# **Coyote Prairie Phase 3 Vernal Pool Construction**

## **As- Built Report**

November 6, 2009

Oregon Department of State Lands Permit No: 42724-RF  
Army Corps of Engineers Permit No: NWP-1995-1157

# Coyote Prairie Phase 3 Vernal Pool Plan

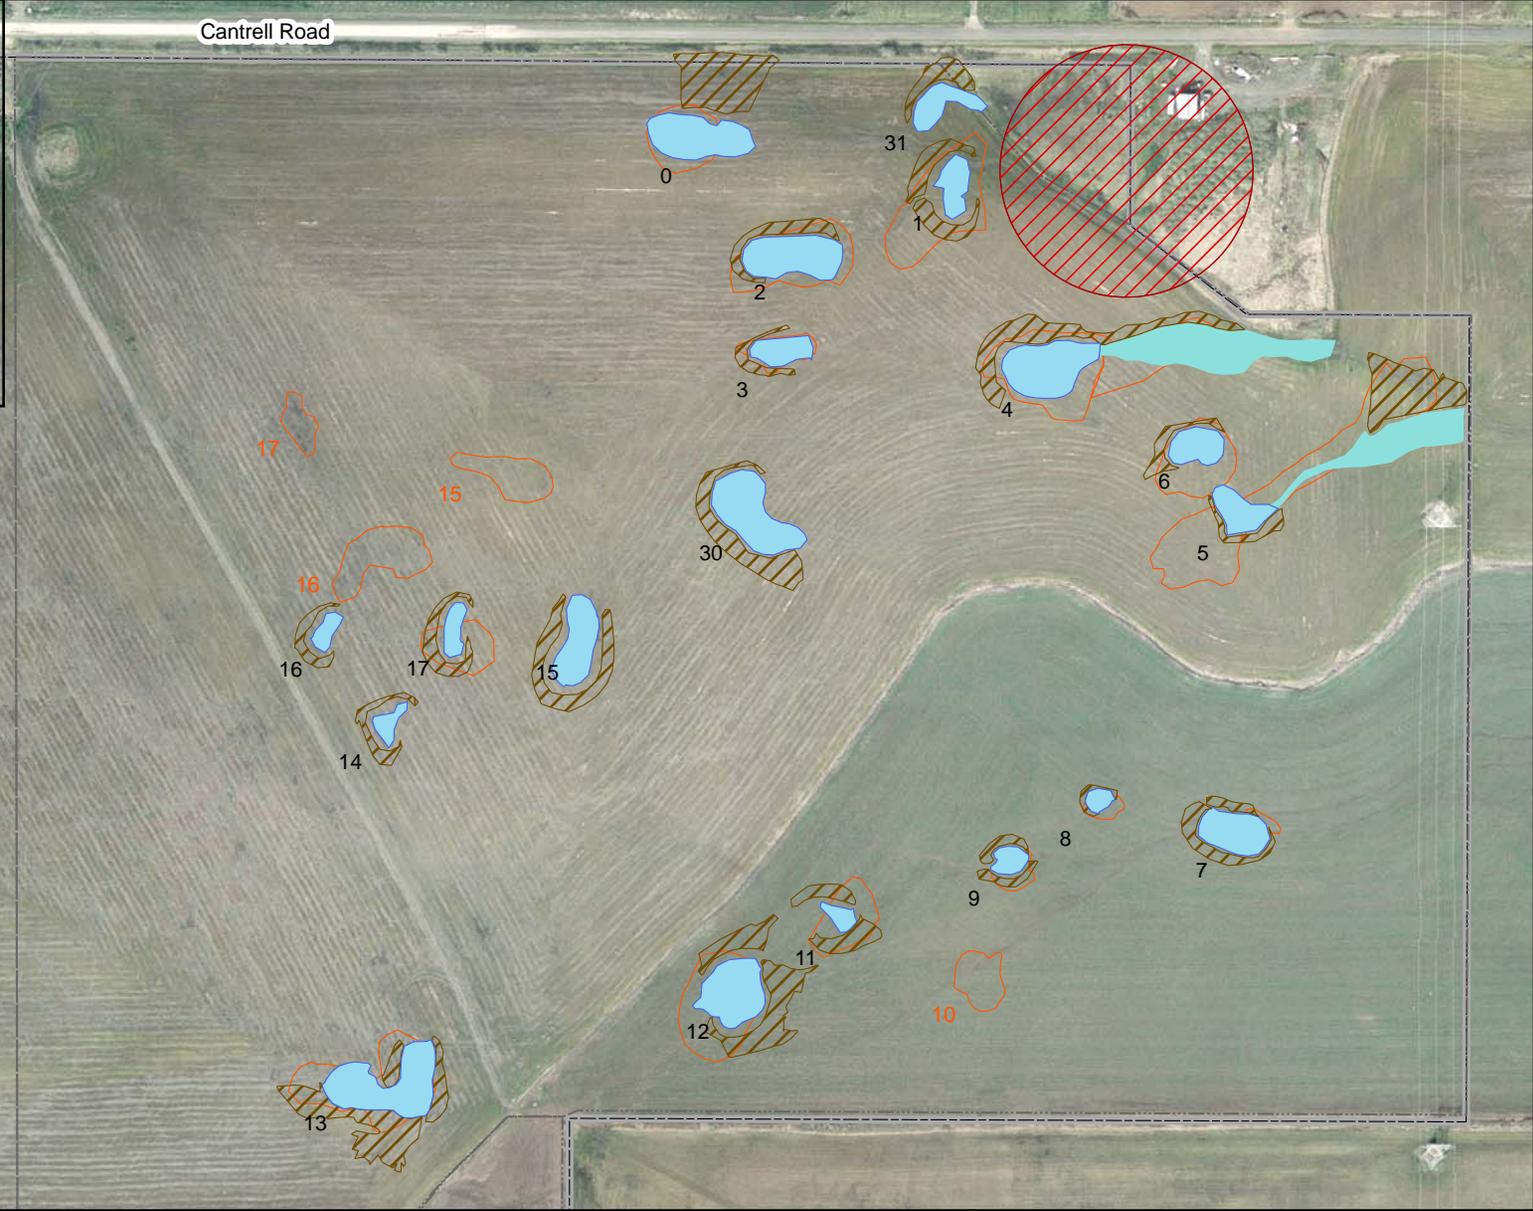
The approved project plans were partially modified in August to take in to account a protective buffer for rare plants, and additional slope and topography information gathered on the site. Prior to beginning work on the site, a 200 foot protective buffer/work exclusion zone (WEZ) was installed around perimeter of an existing Bradshaw’s lomatium population using wood tree stakes and yellow caution tape on Sept. 9<sup>th</sup>. The location and size of the WEZ was established as part of an informal consultation with the U.S. Fish and Wildlife Service on the potential impacts of the project’s actions to a Bradshaw’s lomatium population located on the site (refer to TS Number 09-1602; Tails Number: 13420-2009-10-1 30 for a copy of the informal consultation for this project). The location of the 200 foot WEZ required the relocation and redesign of Pools 1 and 4 as depicted on the attached As-Built map. In addition, design refinements in August led to the relocation and size adjustments to Pools 14, 15, 16 and 17. Furthermore, during construction, it was decided that Pool 10 would not be constructed and that a new pool (Pool #30) would be added to the central portion of Phase 3. The decision to add Pool #30 was based on additional site analysis and the adjustment to Pools #s 4, 5 and 6.

<b>Pool #</b>	<b>Modification or Change</b>
<b>0</b>	A 0.27 acre area north of the pool was re-graded to eliminate a farmer’s drainage ditch which channeled water off the site. Surface flow is now directed toward Pool #0 and released towards the center of the site.
<b>1</b>	Pool #1 was reduced in size and divided into two smaller pools. The new pools are labeled 1 and 31 on the accompanying As-Built map.
<b>2</b>	Pool #2 was reduced in size.
<b>3</b>	No change
<b>4 &amp; Swale</b>	Pool #4 was reduced in size and the swale was realigned to better intersect with the existing slope.
<b>5 &amp; Swale</b>	Pool #5 was reduced in size and designed to discharge across the slope towards pool #6. Pool #5 as constructed is 0.10 acres in size. In addition a 0.25 acre area located up slope of the pool was re-graded to eliminate a drainage ditch and to redirect runoff away from the edge of the site toward pool #5.

<b>6</b>	The size of pool #6 was reduced to shrink the amount of water pooled on the slope. Water to a depth of 6 inches will still be retained in Pool #6.
<b>7</b>	No change, built as proposed. The pool as depicted on the map submitted with the application incorrectly depicts the size of the pool (map error).
<b>8</b>	Built as proposed.
<b>9</b>	Modified within the proposed footprint due to existing slope. This is now a two chamber pool which should allow more water to be retained for a longer period of time.
<b>10</b>	Pool #10 was not constructed due to site conditions.
<b>11</b>	Pool #11 was reduced in size to better fit site conditions (e.g. slope). The max depth of 4 inches did not change.
<b>12</b>	Reduced in size, otherwise built as proposed.

Pool #	Modification or Change
13	This dual chamber pool was built as proposed. The fill mounds are used to retain water within the pools.
14	Pool #14 was relocated and reduced in size.
15	Pool #15 was relocated, reduced in size and reshaped.
16	Pool #16 was relocated, reduced in size and reshaped.
17	Pool #17 was relocated, reduced in size and reshaped.
30	Pool #30 is a new pool not in the original proposal. It was added to capture flows in the center of the site. The 0.24 acre pool is a maximum of 4 inches deep. The excavated native soil around the pool creates a foot print of 0.18 acres.
31	Pool 31 was added to capture any flow that may remain in the drainage ditch running along the edge of the remnant prairie. A 0.08 acre fill footprint effectively blocks the mouth of the ditch preventing flow from discharging into the roadside ditch.
